Final Drainage Report
for Church at Bent Grass Meadows

PCD File No. SF268

EPC STORMWATER REVIEW COMMENTS
IN ORANGE BOXES WITH BLACK TEXT

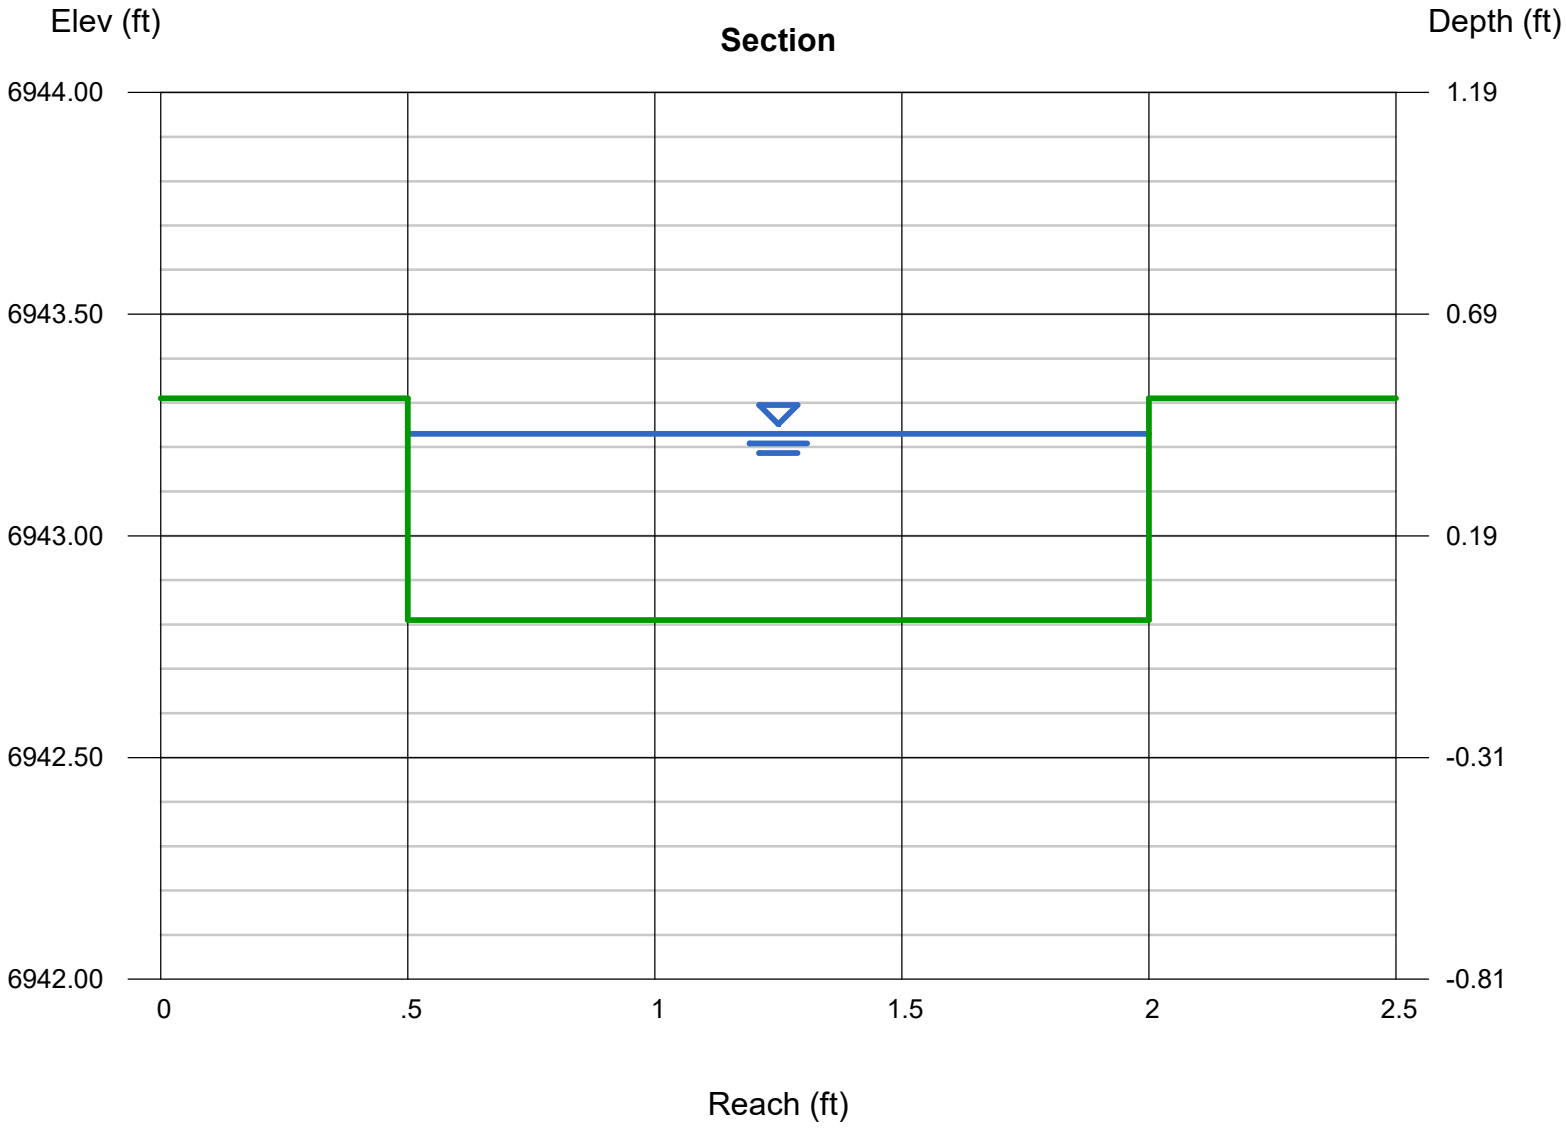
Bottom width is 2.50' on Sheet PCM 6 of CDs. Please revise.

HRG Response:
Concrete rundown A3 updated on PCM Plan to match calculation.

Culvert Report

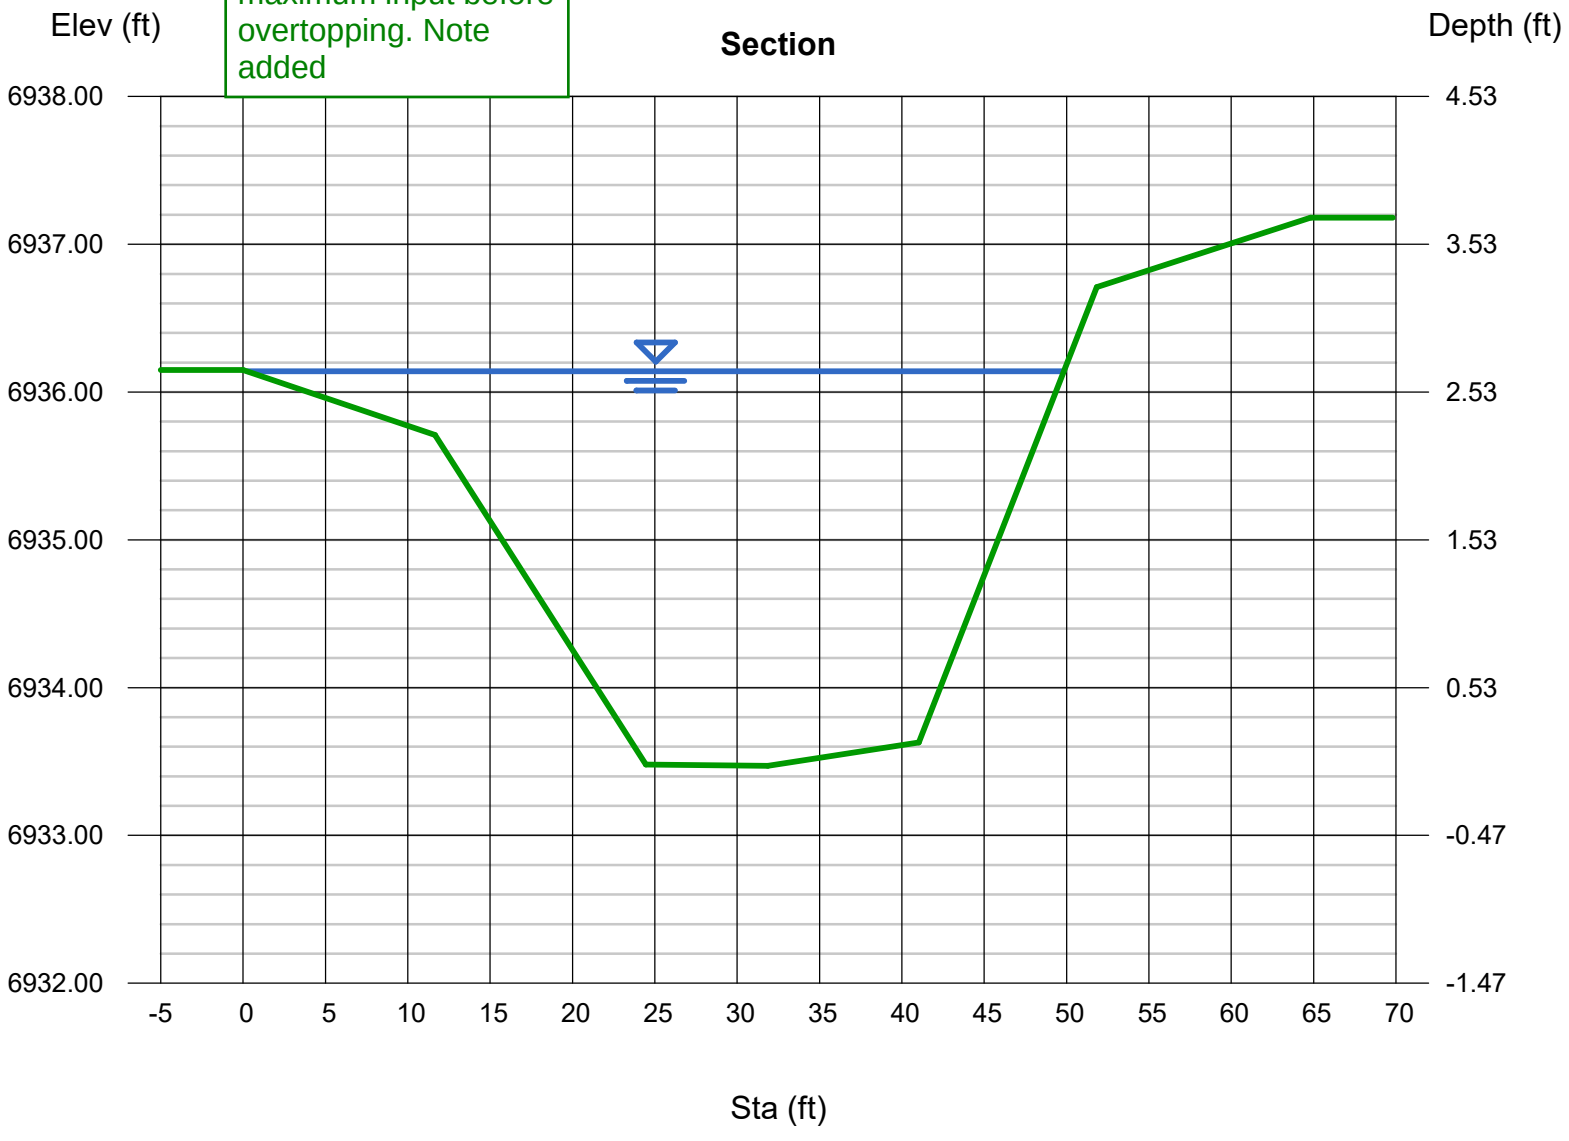
Please specify how this flow rate was determined and identify the source of the value.

HRG Response:
Flow rate was the maximum input before overtopping. Note added

HRGreen	CHURCH AT BENT GRASS	Calc'd by:	CMD
	2403591	Checked by:	RDL
	DP A3 RUNDOWN RIPRAP	Date:	7/23/2026

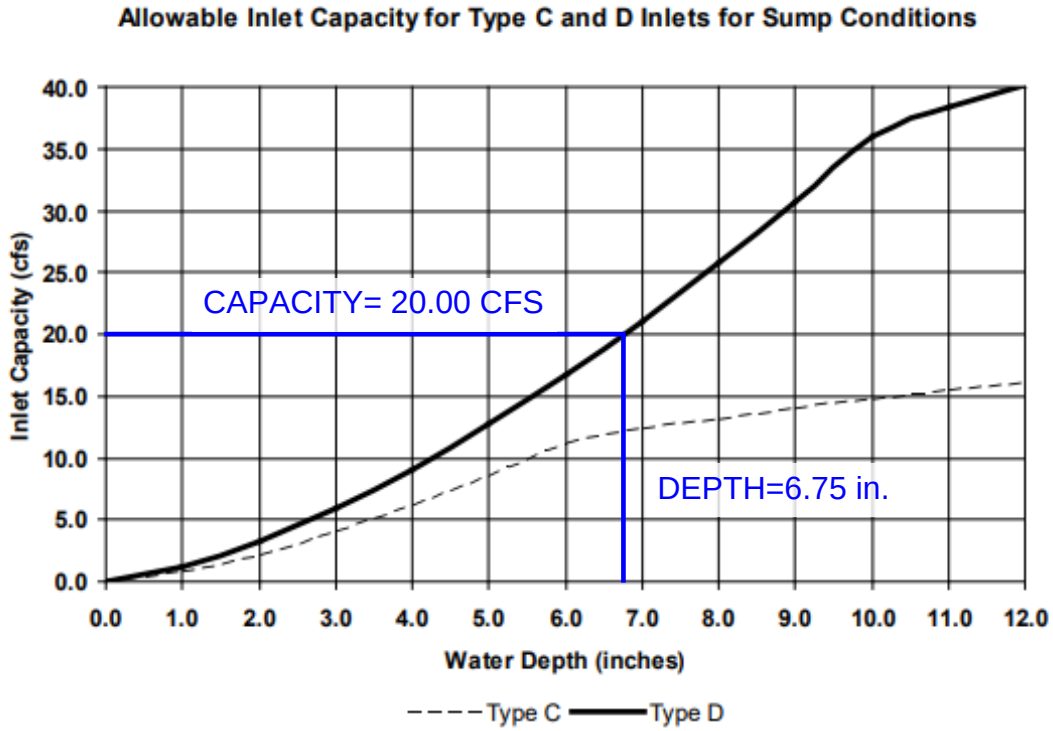
Bottom width is 2.50' on Sheet PCM 6 of CDs. Please revise.

HRG Response: Concrete rundown A3 updated on PCM Plan to match calculation.

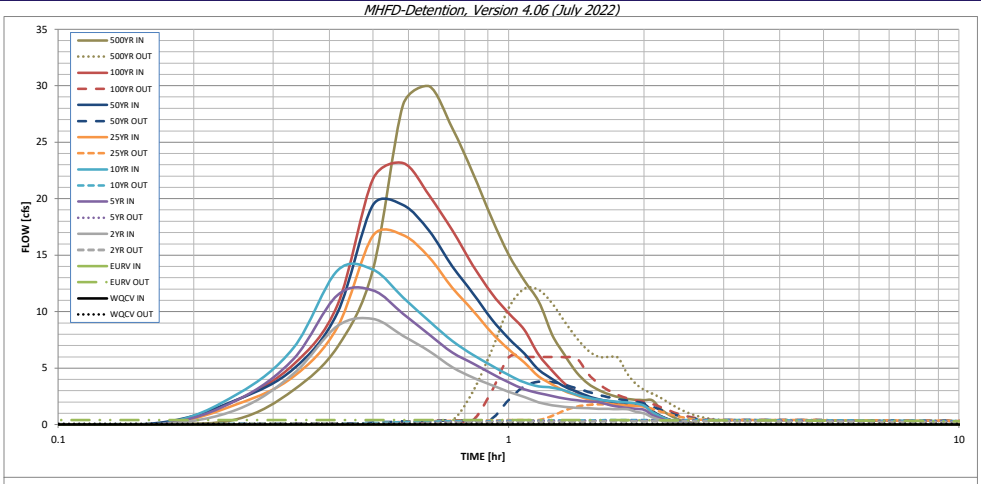
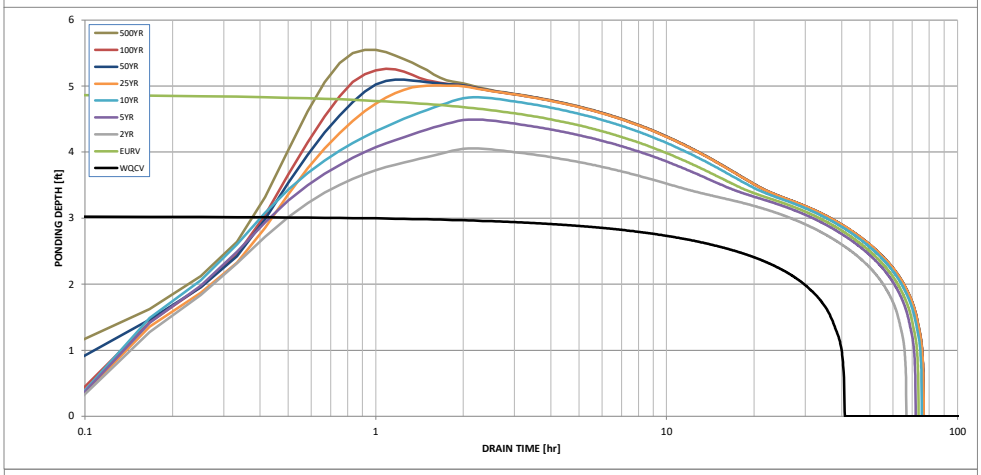
plans call out 5:1

Explain why these are overridden in the text and add a note

HRG Response: Removed overwrite on WQCV and EURV

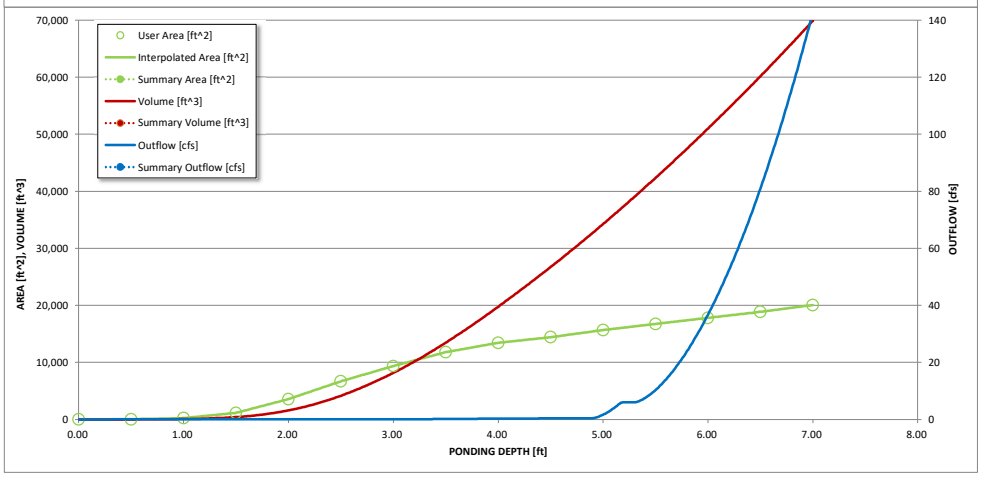
Please discuss in narrative why 1.0 could not be achieved and that impacts are negligible.

HRG Res Restrictor and spillw to achieve
